D1.2 Comments

Comment#180,#181,#182

Chris DiMinico
MC Communications/PHY-SI LLC/Panduit
cdiminico@ieee.org

162B.1.3.2 Mated test fixtures differential return loss

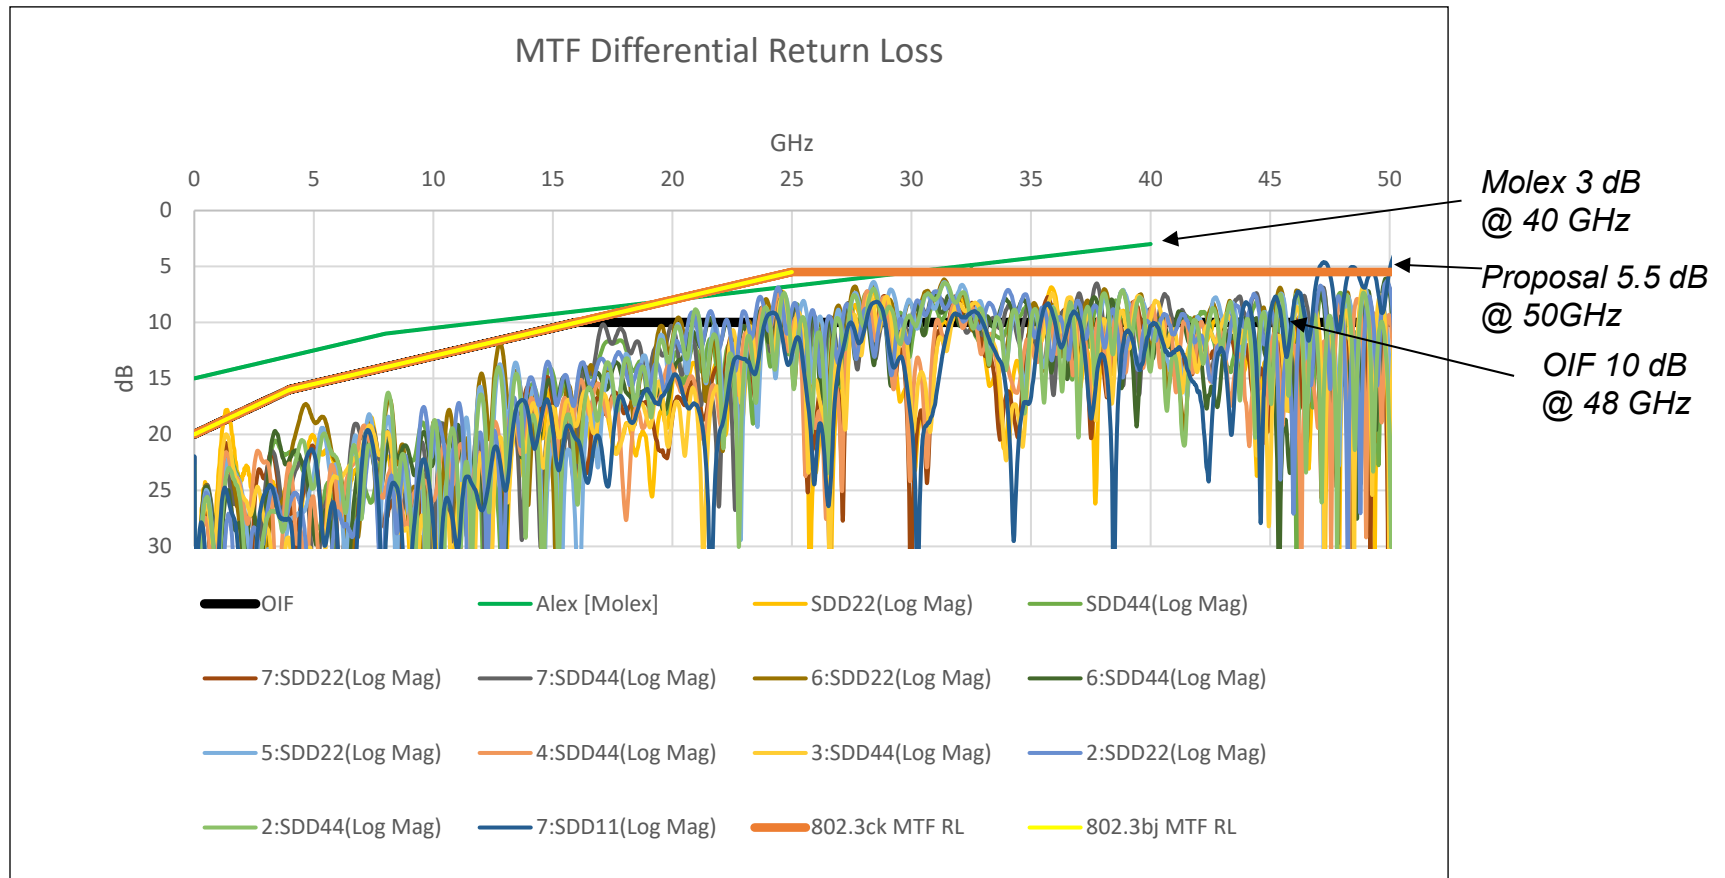
- $DRL(f) \geq TBD$

Differential Return Loss =

$20 - f_{\text{GHz}}$ $0.01/0.05 \text{ (TBD) GHz} \leq f_{\text{GHz}} < 4 \text{ GHz}$

$18 - 0.5 * f_{\text{GHz}}$ $4 \text{ GHz} \leq f_{\text{GHz}} < 25 \text{ GHz}$

5.5 $25 \text{ GHz} \leq f_{\text{GHz}} < 40/50 \text{ (TBD) GHz}$

162B.1.3.3 Mated test fixtures common-mode conversion insertion loss

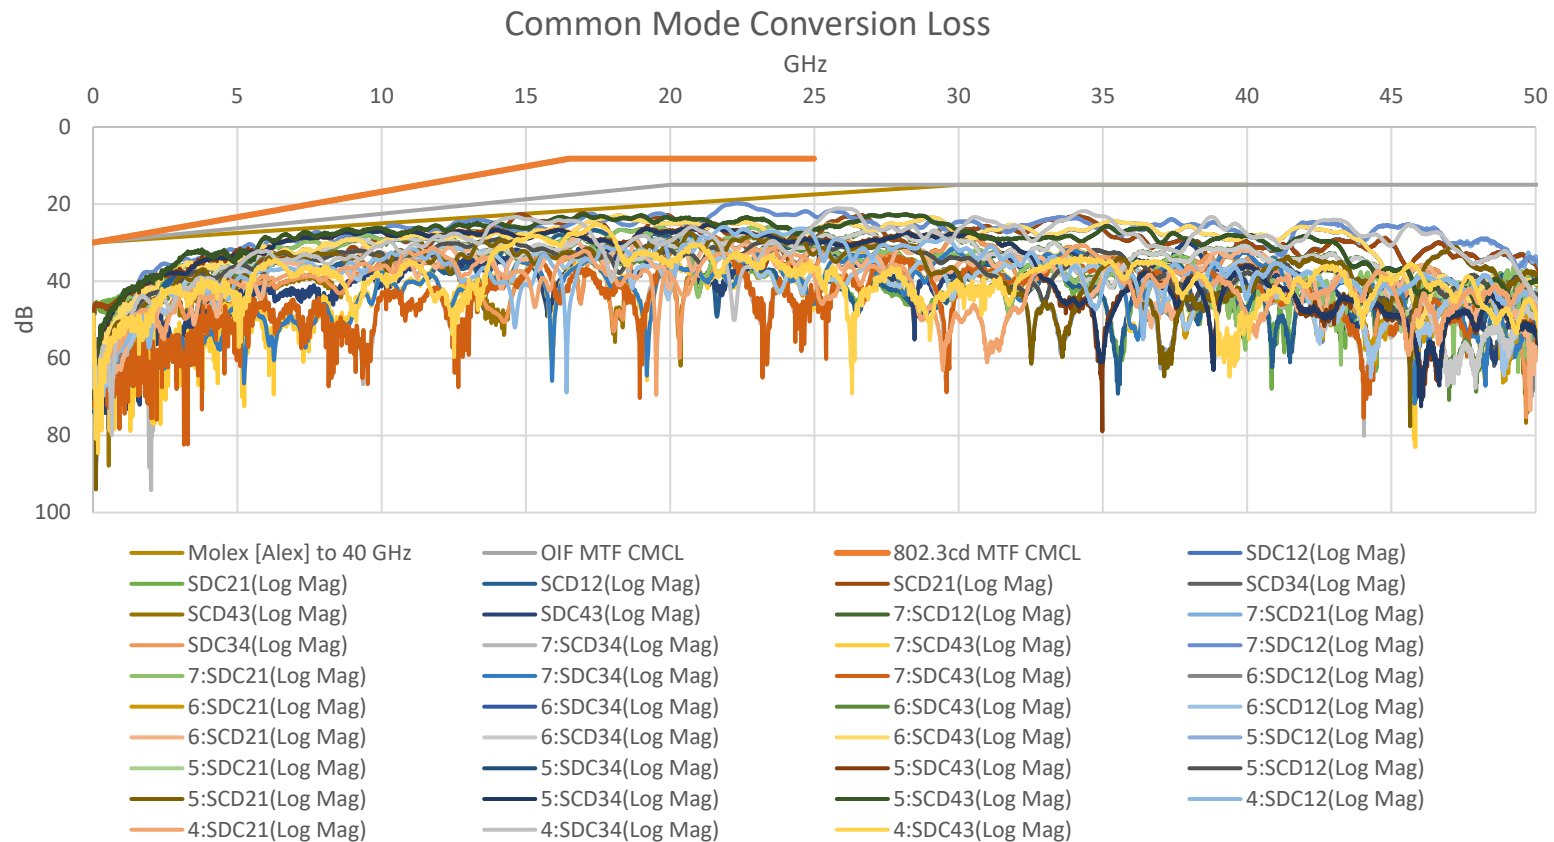
- $CMCIL(f) \geq TBD$

Common Mode Conversion Loss =

$30 - 0.5 \cdot f_{\text{GHz}}$ $0.01/0.05 \text{ TBD GHz} \leq f_{\text{GHz}} < 30 \text{ GHz}$

15 $30 \text{ GHz} \leq f_{\text{GHz}} \leq 40/50 \text{ TBD GHz}$
